JUANITA FARMHOUSE COTTAGES PROJECT

City of Kirkland Reviewed by T Elder 03/25/2016

BUILDING PERMIT APPLICATION for THE BLUE SPRUCE under INTEGRATED DEVELOPMENT PROCESS and BUILT GREEN expedited Review Process

BXUV.U334 - Fire Resistance Ratings - ANSI/UL 263

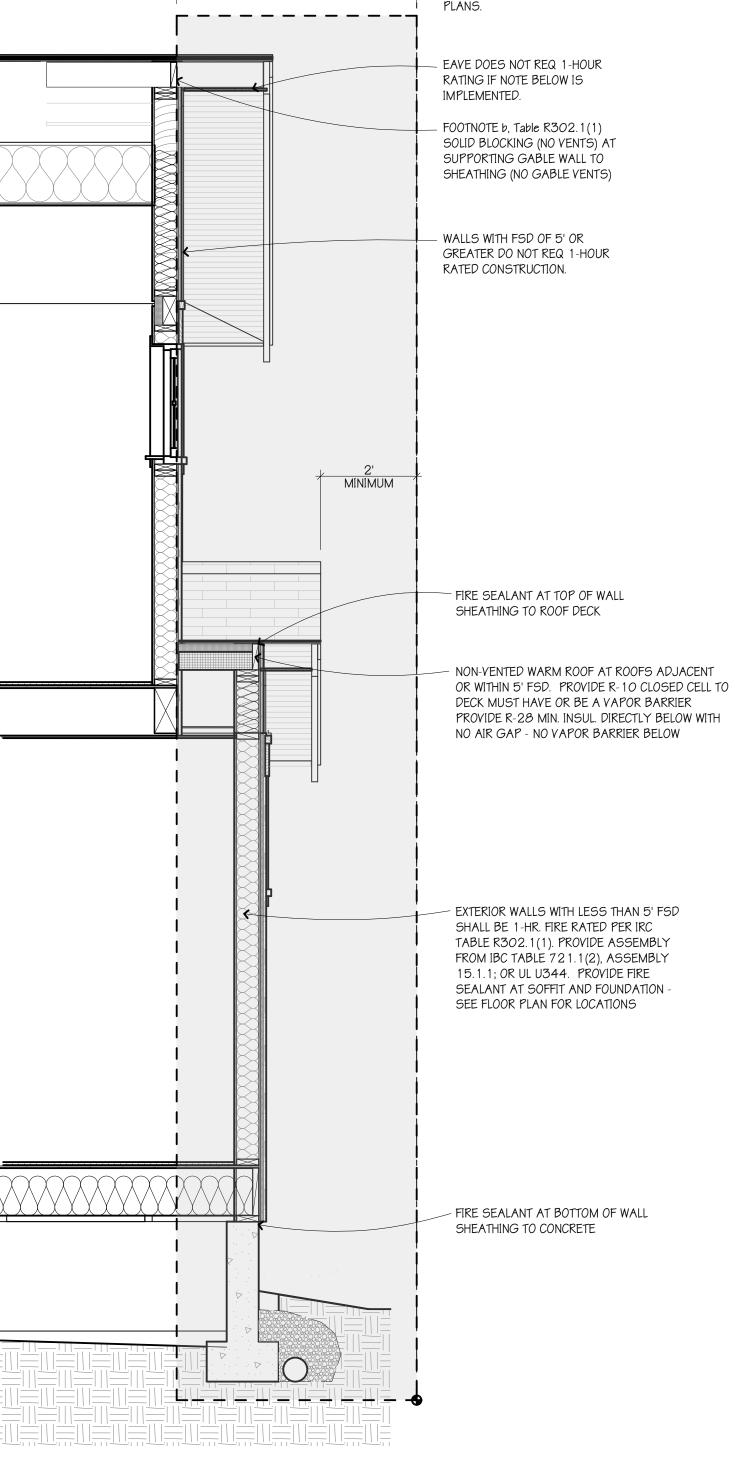
Code requires a minimum 1-hr rated wall assembly for this application. The reviewed approved plans show construction of this 2-hr rated wall assembly (U344). If this is to be modified, a REVISION must be submitted to show the new assembly
